TALLAWONG STATION **PRECINCT SOUTH**

ADDENDUM URBAN DESIGN REPORT

Rev. E_10.12.2020

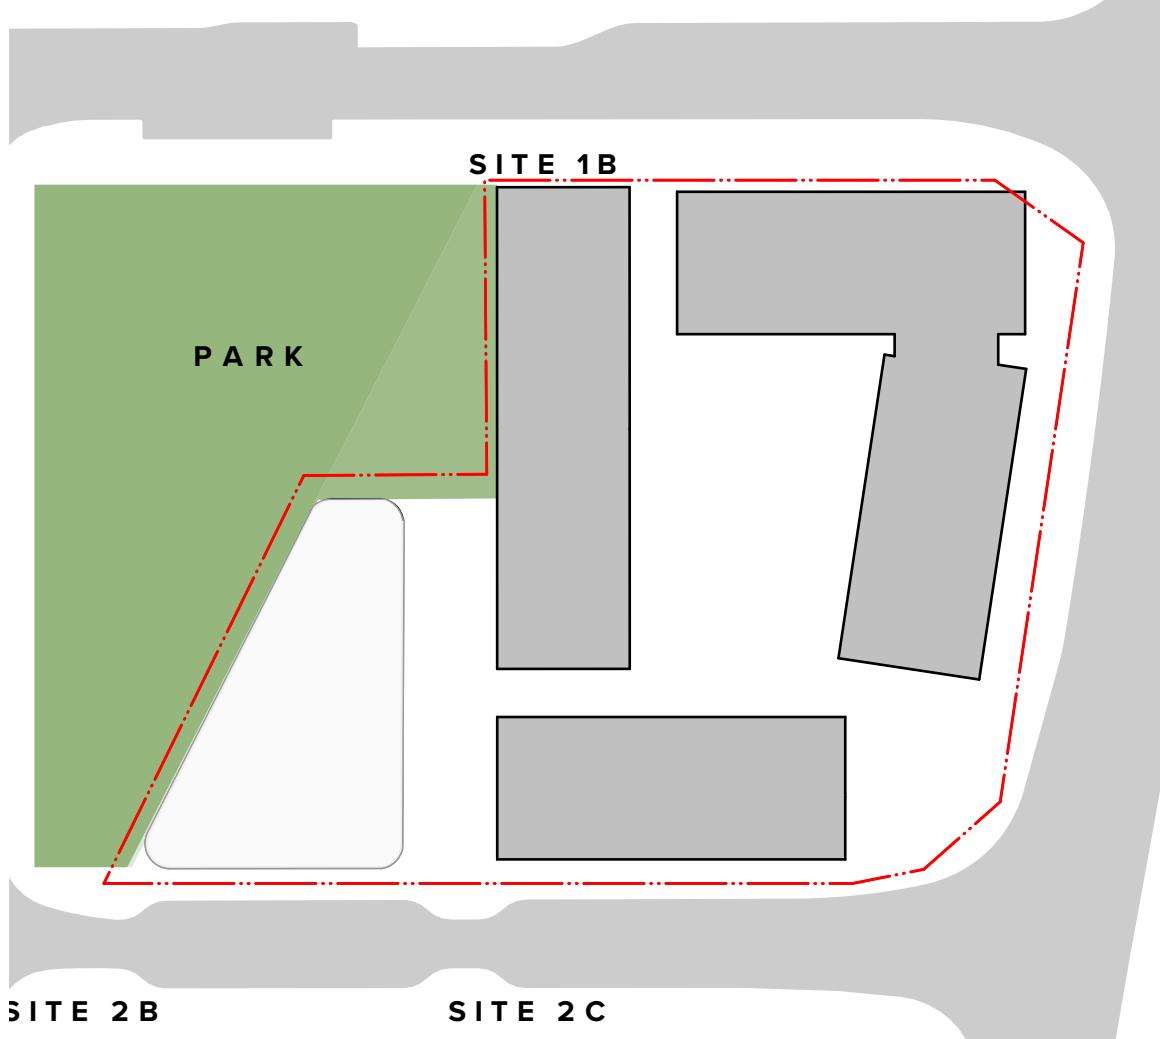
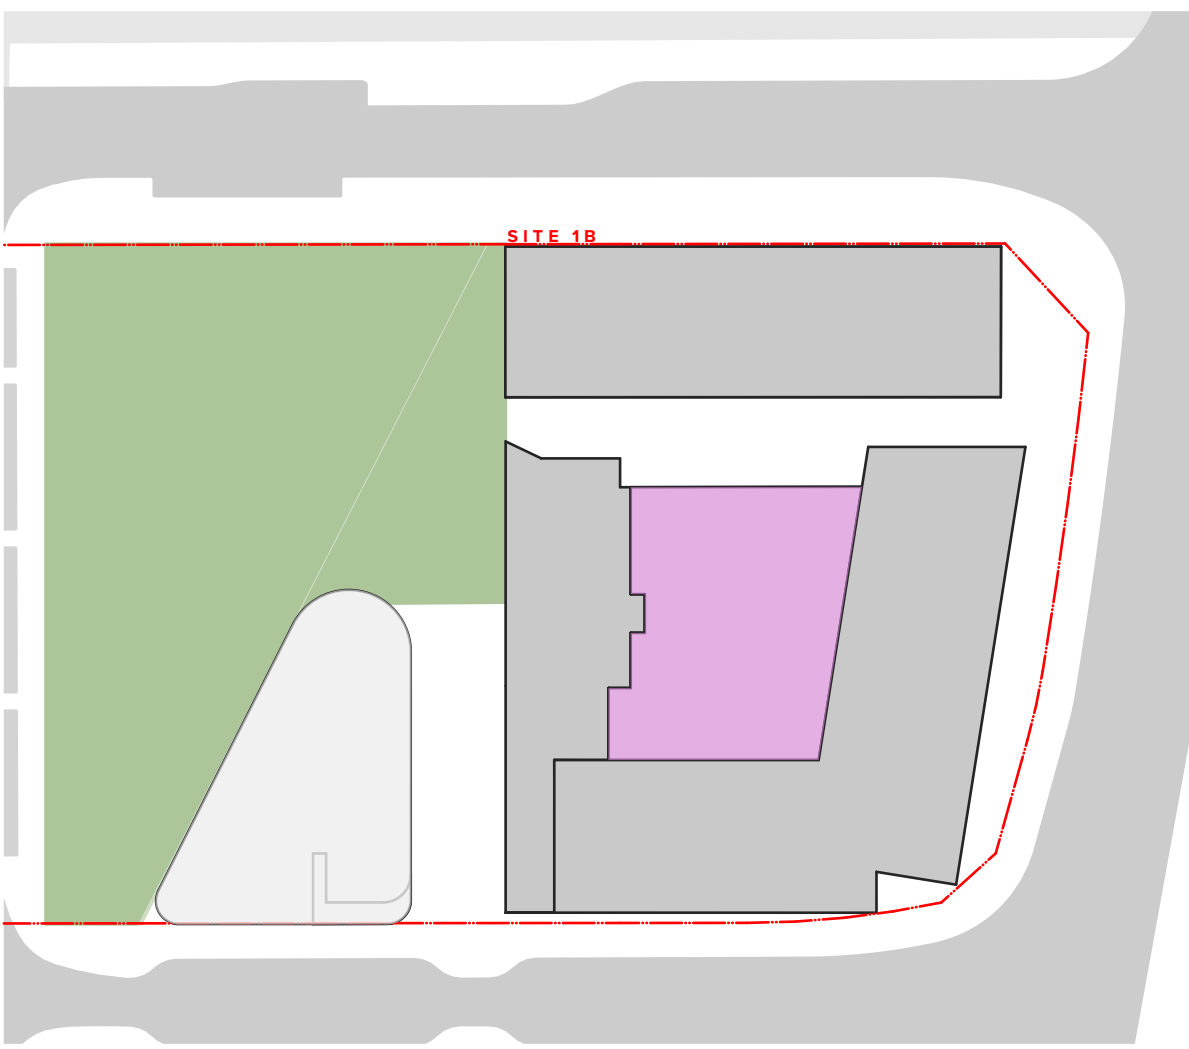
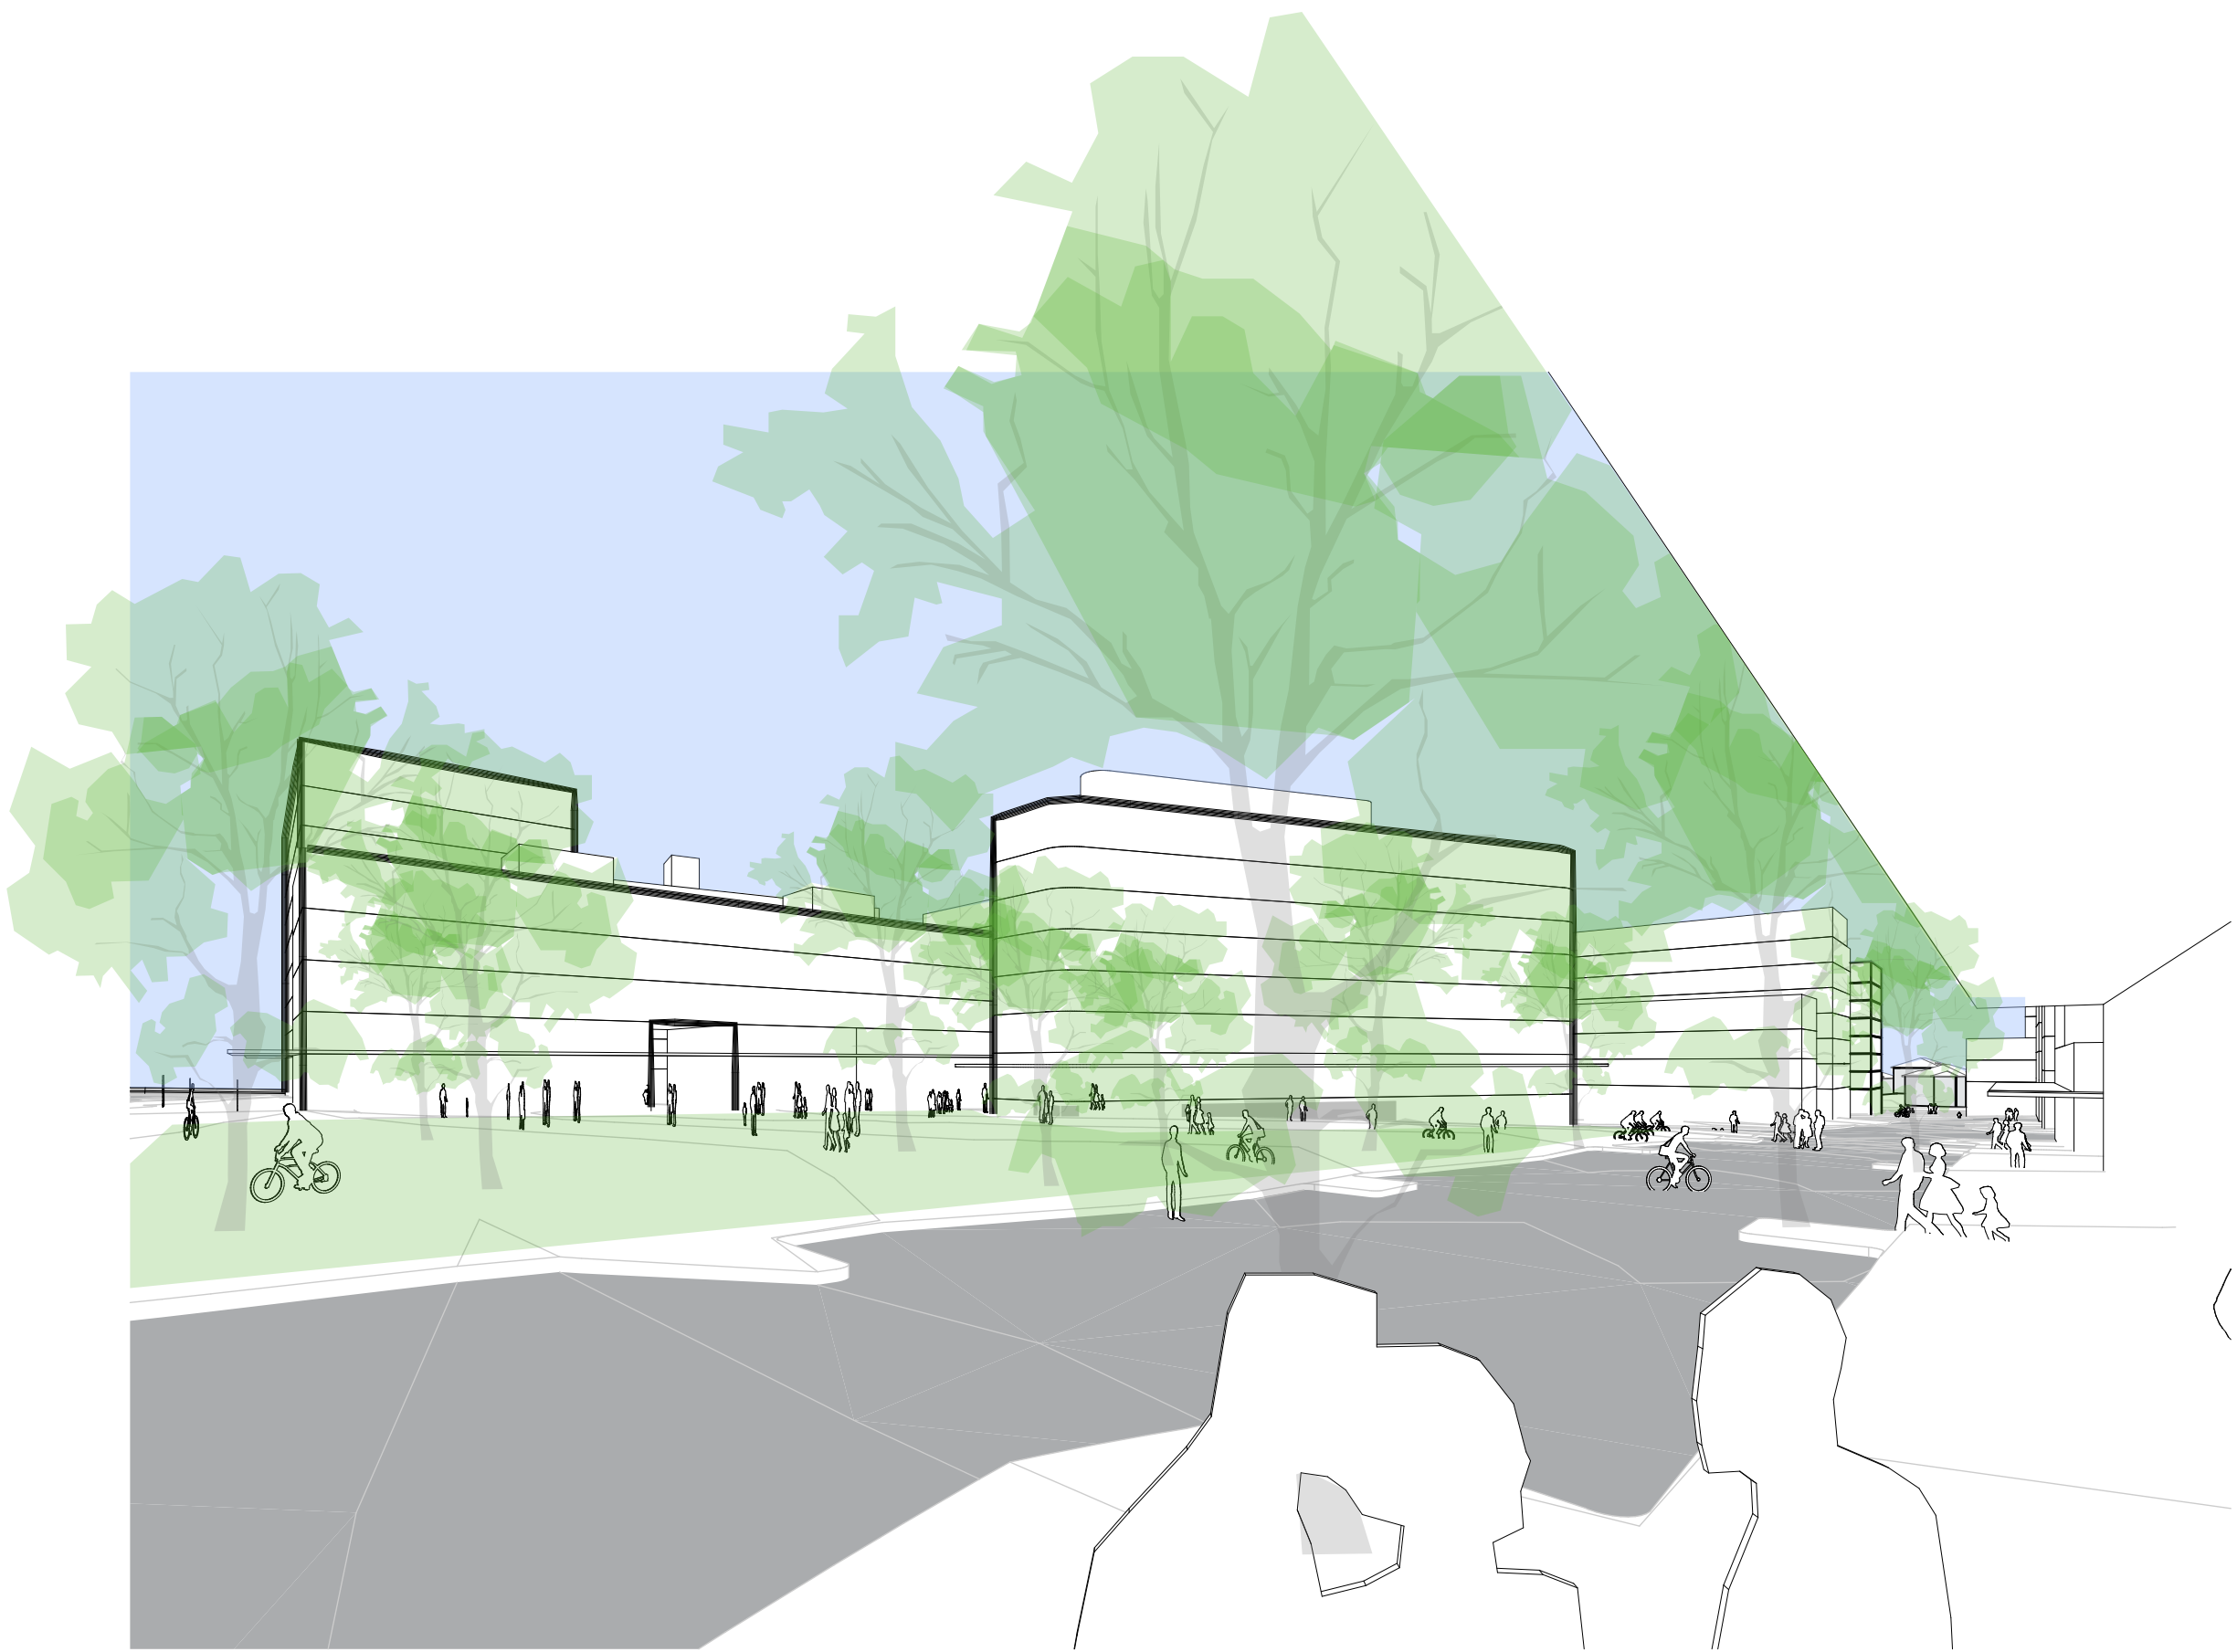
- ✓ Shift building forms to respond to new through site link
- ✓ Reconfigure the built form to define the corner of Cudgegong Road and Conferta Avenue, creating a gateway to the residential precinct
